<b>Project</b>	Steamboat Base Village Redevelopment	<b>Date</b>	08/04/2021
<b>Project Location</b>	Steamboat, Colorado	<b>Architect's Project Number</b>	03.7835.000
<b>Owner/Client</b>	Alterra Mountain Company / East West Partners	<b>File</b>	6BL <b>This is page</b> 1 of
<b>To</b>	Saunders Construction Inc.	<b>Attention</b>	Bryan Sculthorpe
<b>Address</b>	86 Inverness Place North		
<b>City</b>	Englewood	<b>State</b>	CO <b>Zip Code</b> 80112
<b>Delivered via:</b>	<input type="checkbox"/> <b>Messenger</b> <input type="checkbox"/> <b>Hand carried</b> <input type="checkbox"/> <b>Facsimile</b> <input type="checkbox"/> <b>Express</b> <input type="checkbox"/> <b>Pick-up</b> <input type="checkbox"/> <b>E-mail Address</b> <input type="checkbox"/> <b>Mail</b> <input type="checkbox"/> <b>UPS</b> <input checked="" type="checkbox"/> <b>Website Address</b> BIM360

<b>Attachments</b>	BP3 Goldwalk - BULLETIN 05		
<b>Requested by</b>	<input checked="" type="checkbox"/> Architect <input type="checkbox"/> Owner <input type="checkbox"/> Contractor <input type="checkbox"/> Other (specify): _____		
<b>Issued by Gensler by</b>	Juan Padilla	<b>Date Signed</b>	08/04/21
<b>Issued by Owner by</b>		<b>Date Si

## Description

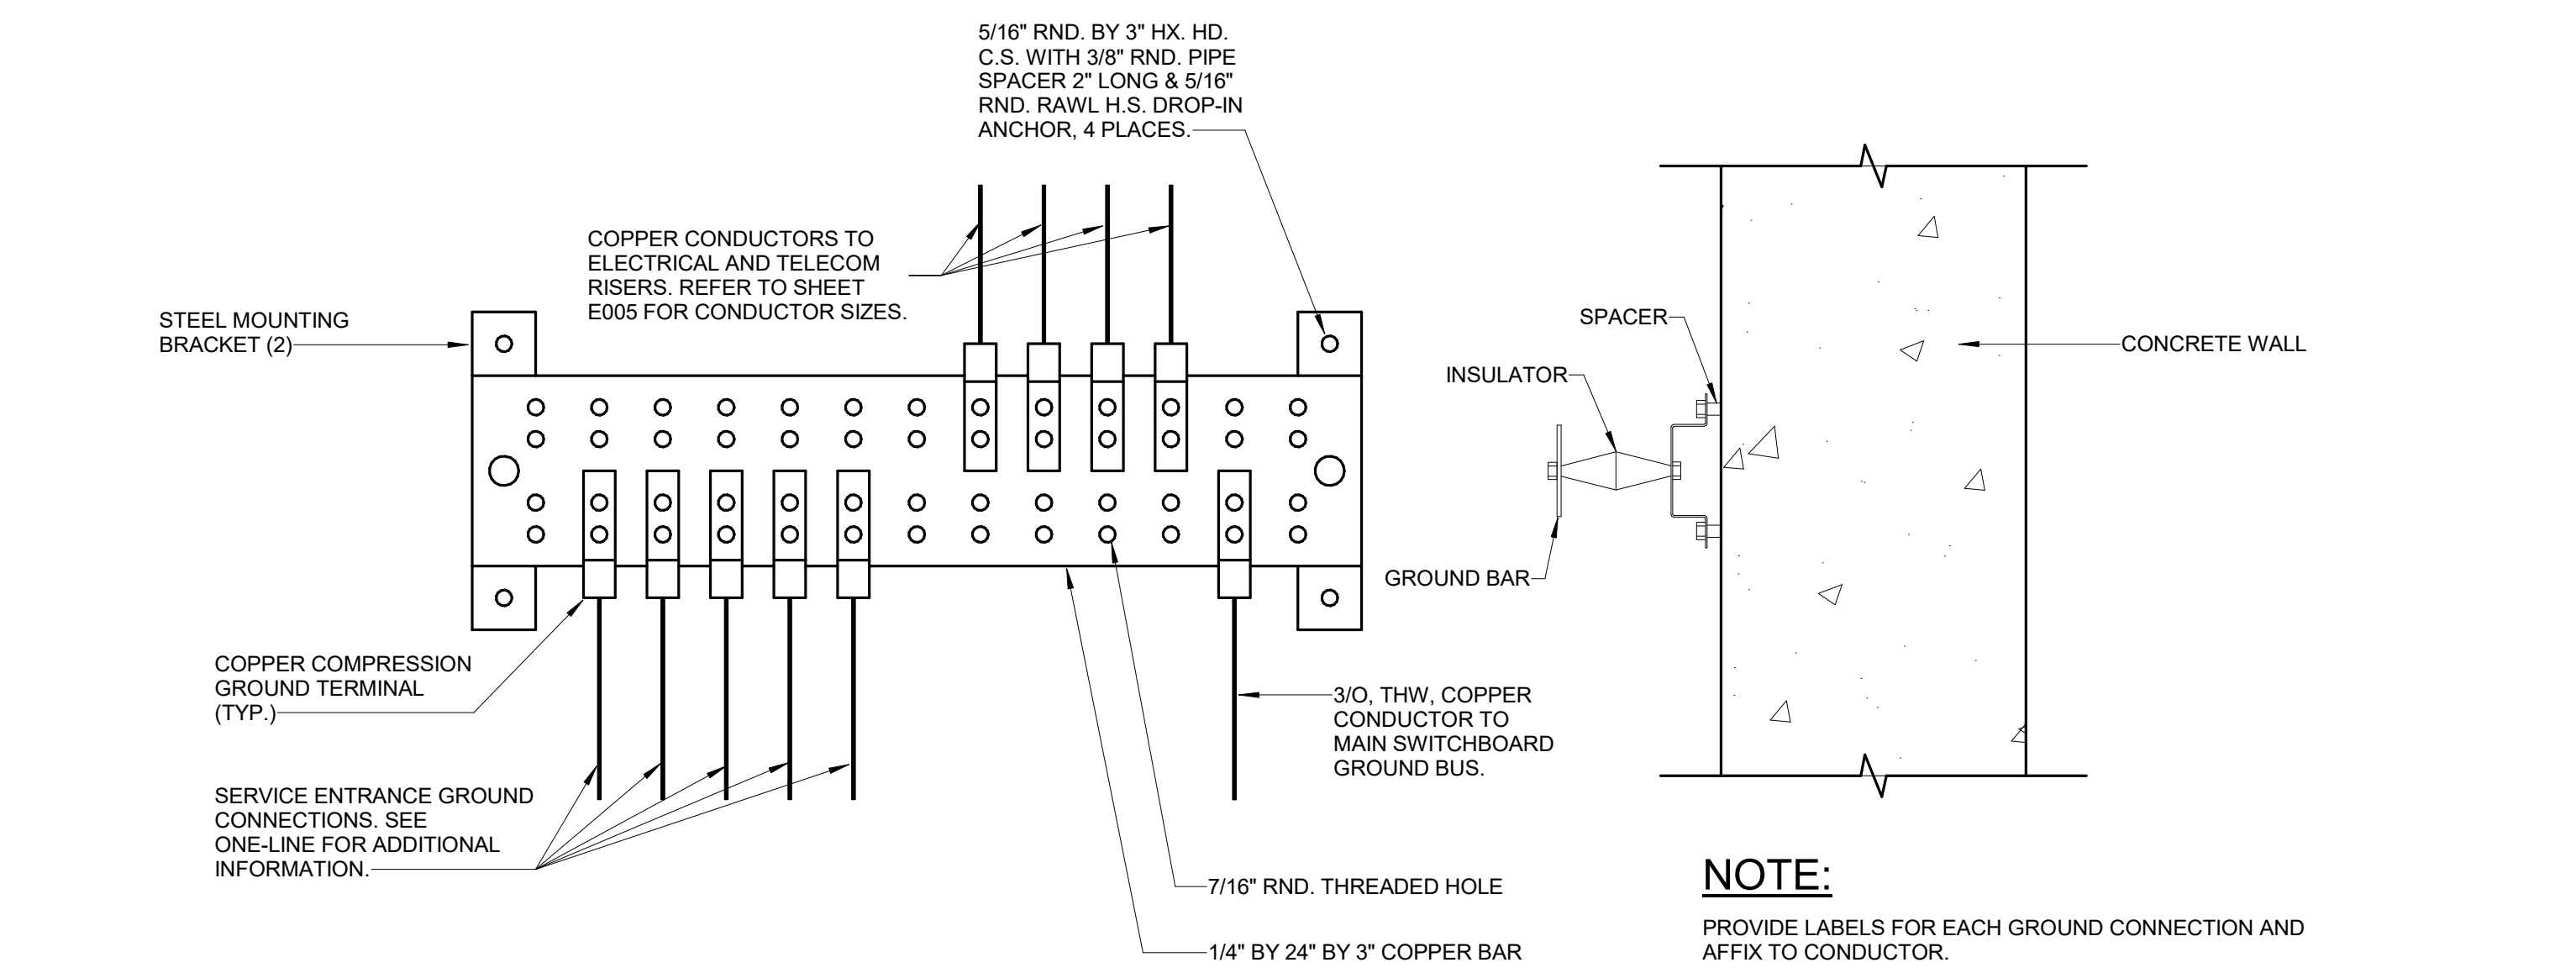
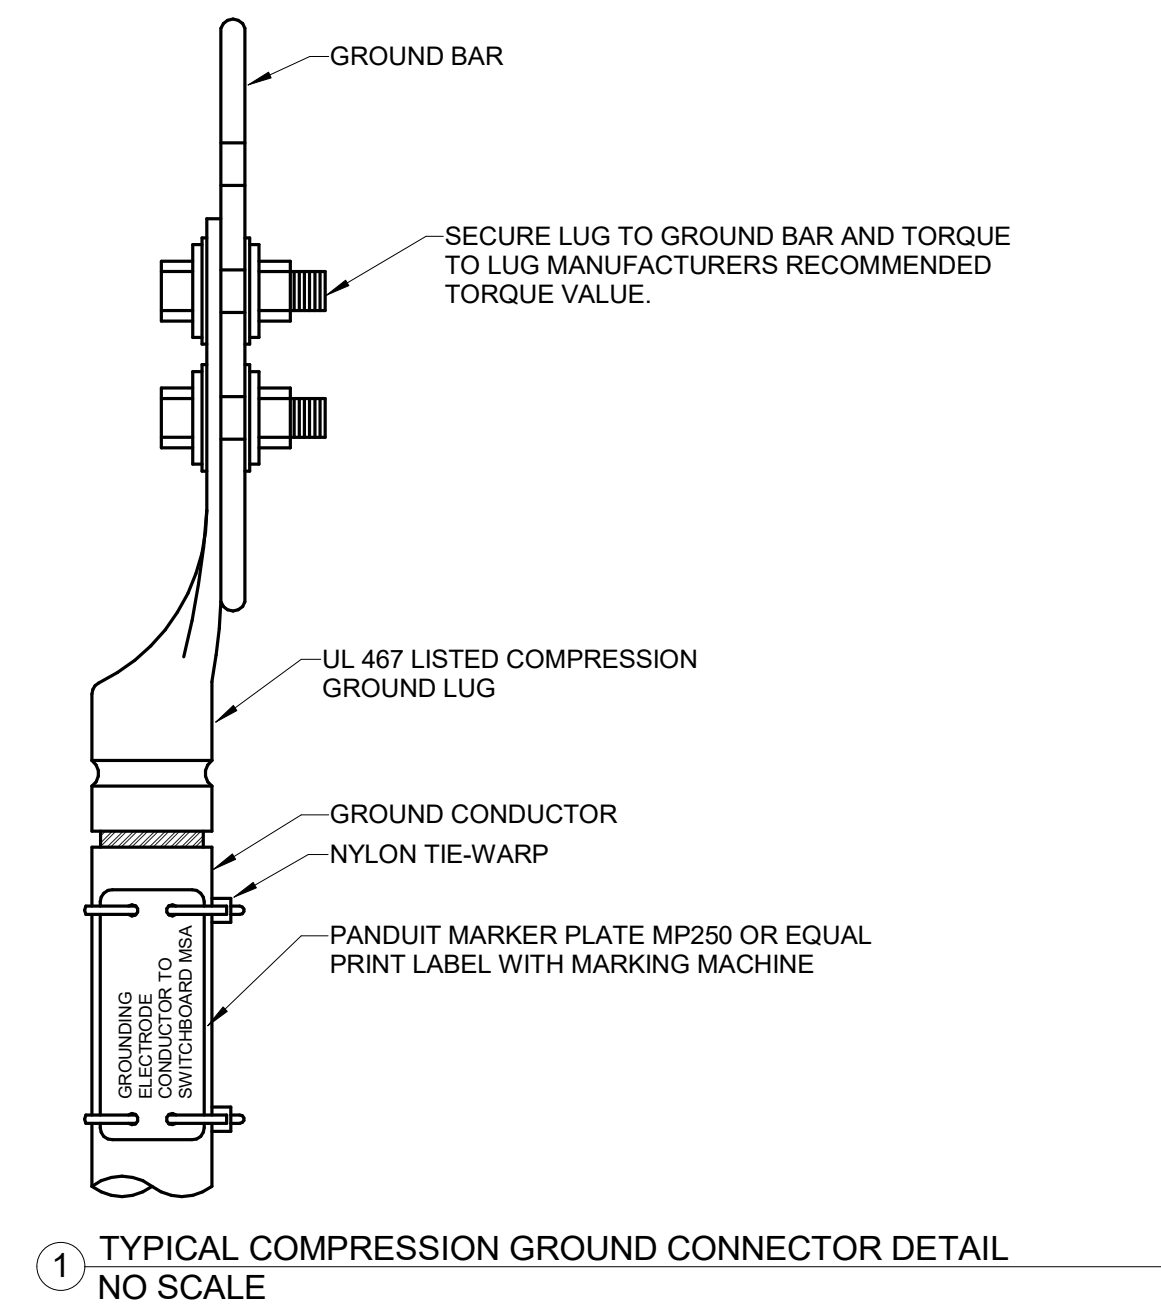
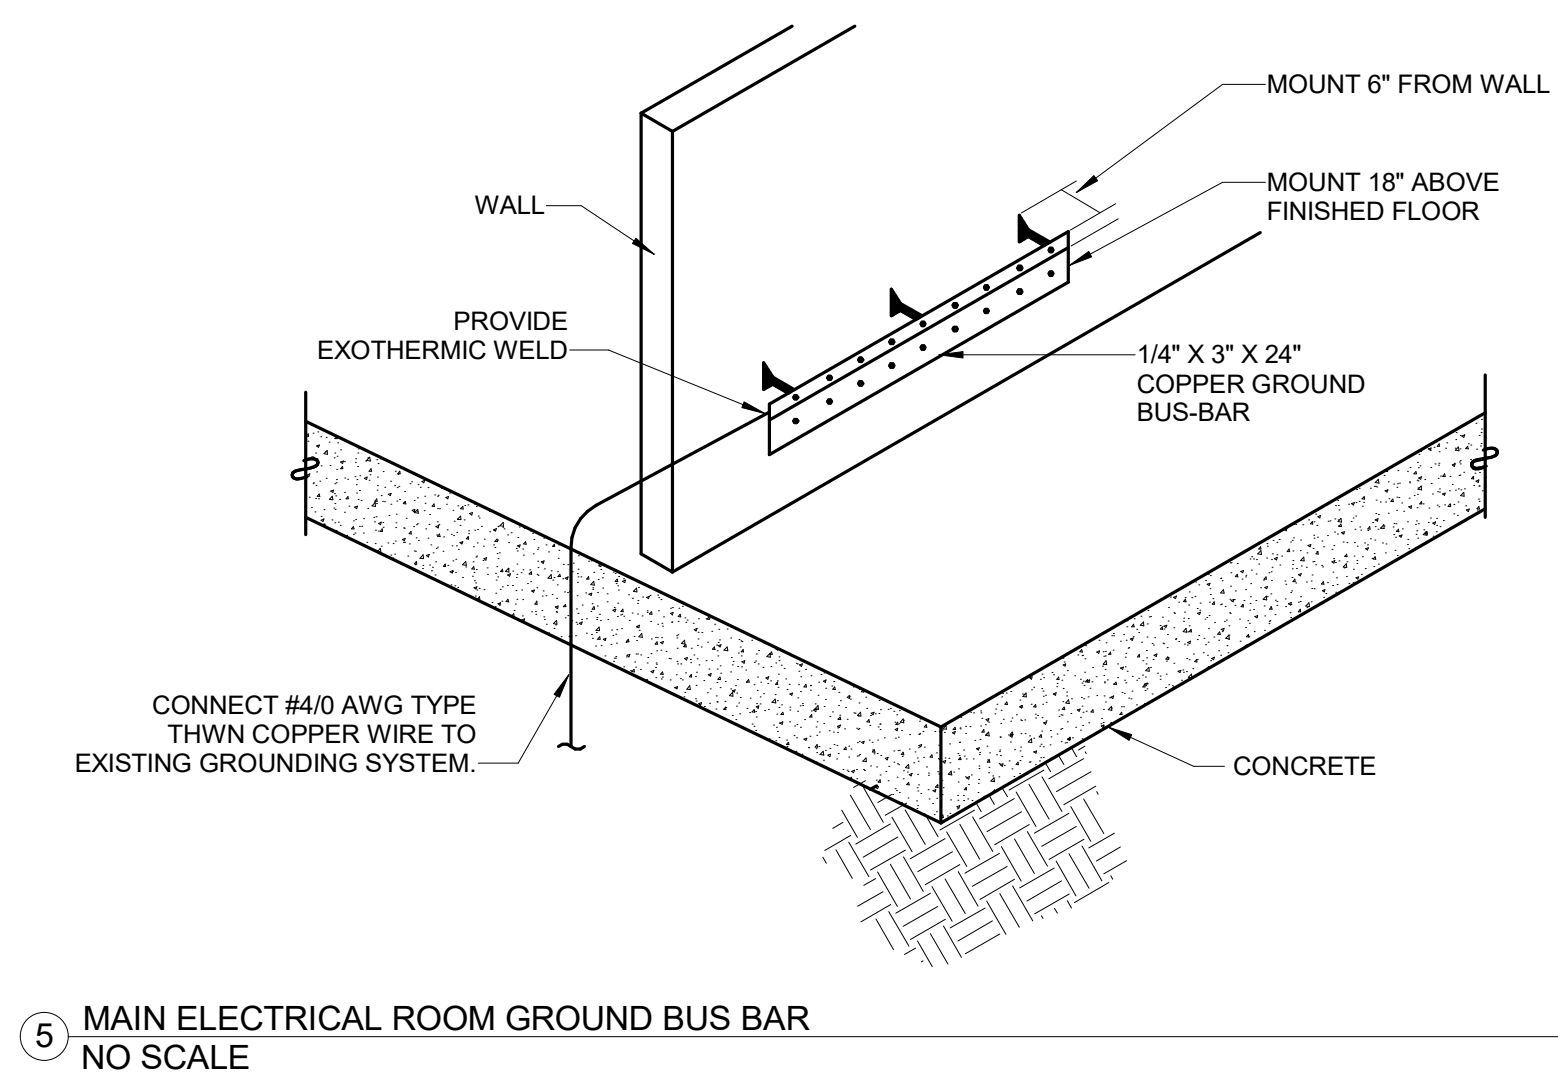
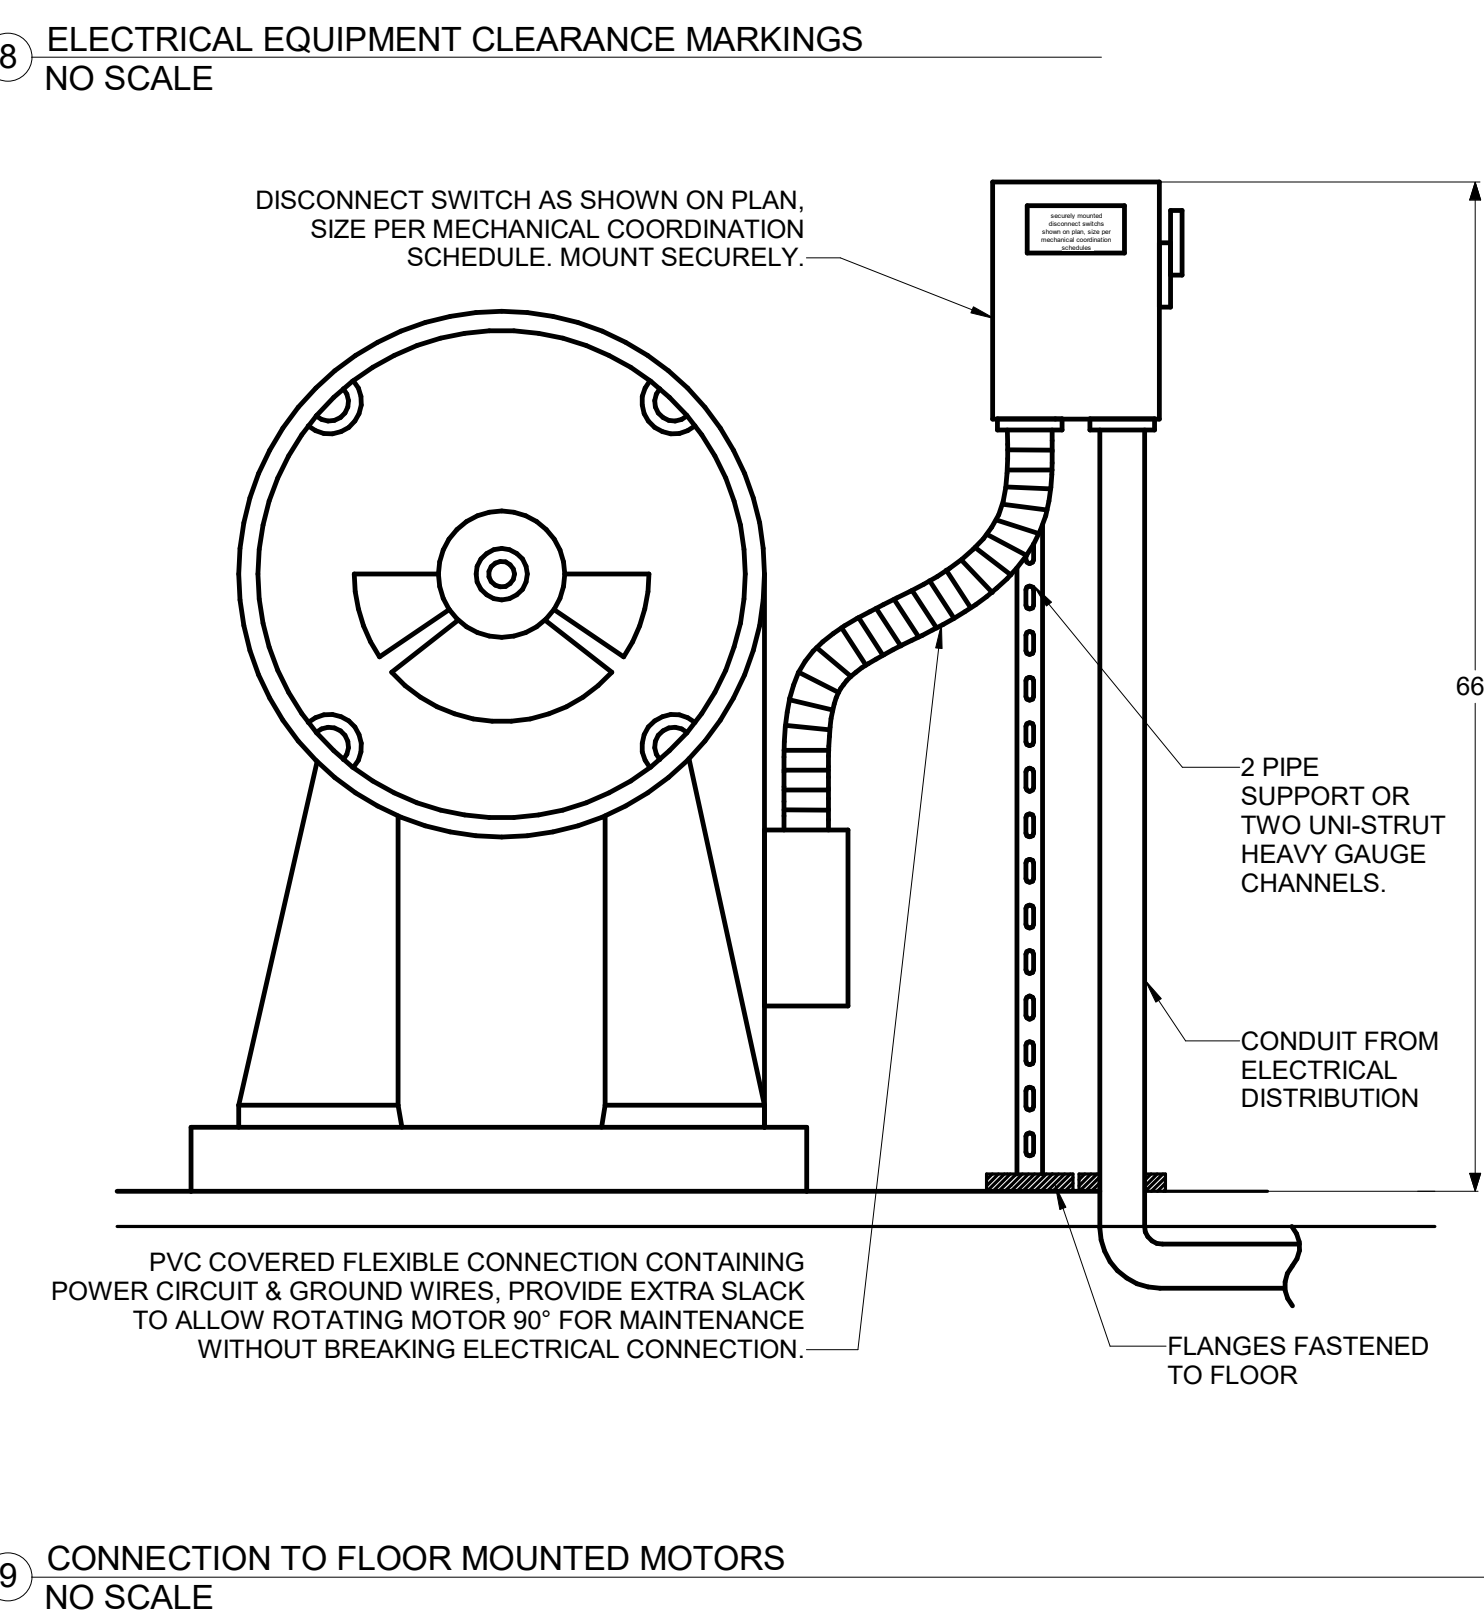
1. 1B-E0.001
  - a. Modified location of new Utility transformer associated with gold walk and Gondola Square loads.
  - b. Modified electrical short circuit values associated with secondary feeder distance reduction.
  - c. Added existing pile caps for reference as reviewed on existing building drawings.
  - d. Added clarification notes to general notes and keynotes for installation of secondary duct bank to be routed under foundation and into electrical gear per coordination with General Contractor.
2. 1B-E8.000
  - a. Added electrical detail for underground concrete encased duct bank from secondary of transformer to electrical service entrance switchboard.
